PILGRIM WATCH

June 14, 2012

SUBJECT: Fukushima Lessons Learned Tier 3 Recommendations- Spent Fuel Pool vs. Dry Storage; Reliable Hardened Vents & Filtration of Containment Vents; Emergency Planning Issues, Expanding Size EPZ, Pre-staging Potassium Iodide Beyond 10 Miles, Monitoring; and Relegating Recommendations To Backfits

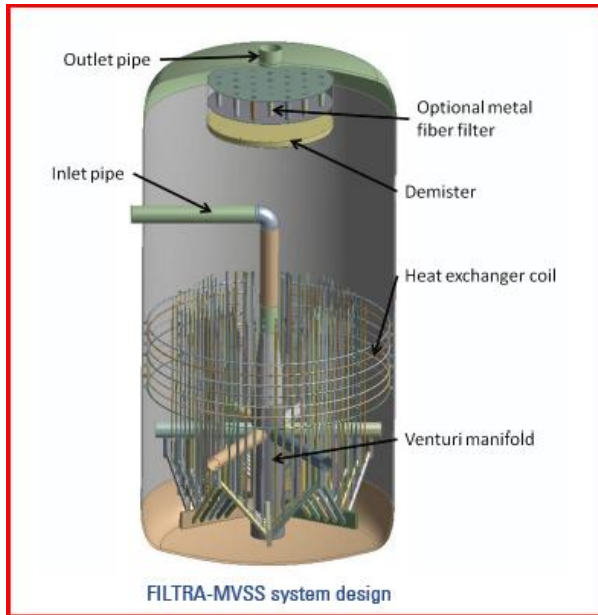
One example: Westinghouse FILTRA-MVSS (multi-venturi scrubber system) is described as a passive, self-regulating system for filtered pressure relief of BWR/PWR reactor containments¹⁷. The system is passively actuated by means of a rupture disc. A typical design basis for the system is a total loss of AC power for 24 hours leading to loss of core cooling ability. This includes a total loss of electrical power from both the external grid and all plant-specific power back-up systems, as well as loss of steam turbine-driven core cooling pumps. It says that

It is designed on Swedish regulations requiring 99.9 % of the core inventory of radioactivity (excluding noble gases) be retained in the containment or filtered in case of venting; and it has high decontamination factors for gas -carried particles, aerosols and elemental iodines. It is fully passive for at least 24 hours after initial venting and requires no startup time.

For a BWR, the FILTRA-MVSS would be connected to the hardened vent. The filter consists of several filtration steps, all of which are contained in the tank: the multi-venturi scrubber, a water pool, a moisture separator, and finally an optional metal fiber filter.

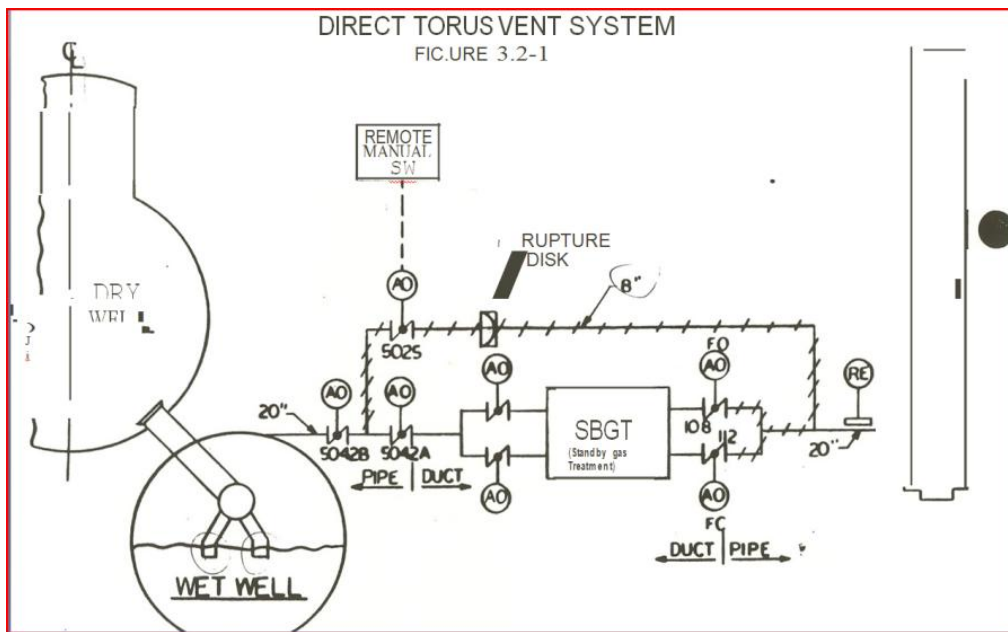
The DTVS provides a new 8" line branching off the existing torus purge exhaust line between the containment isolation valves (outside containment) with a reconnection to the existing torus purge exhaust line downstream of the SGTS. The new torus vent line is also provided with its own containment isolation valve and rupture disc, set to relieve at 30 psig.

The following diagram, that shows the branch line with its own containment isolation valve 5025 and Rupture Disc, is included in the attachment to BECO's letter. It will be noted that the Rupture Disc is downstream of valves AO-5042B and AO-5025, and that both of these valves are normally closed and are designed to be opened either remotely from the control room or manually.²⁰

- An 8” butterfly valve (AO-5025), which can be remotely operated from the control room, is added downstream of 8” valve AO-5052B. This valve acts as the primary containment outboard isolation valve for the DTV line. Test connections are provided upstream and downstream of AO-5025.

- AO-5042B was replaced in 1988 with a DC solenoid valve (powered from essential 125 volt DC) so that it would operate without dependence on AC power. AO-5025 is also provided with a DC solenoid powered from a redundant 125 volt DC source. Both valves are normally closed and are closed in a “fail-safe” position. One inch nitrogen lines are added to provide nitrogen to valves AO-5042B and AO-5025.

- A rupture disc is included in the piping to provide a second leakage barrier. It is designed to open below containment design pressure, but will remain intact up to pressures equal to or greater than those which cause automatic containment isolation during accident conditions.
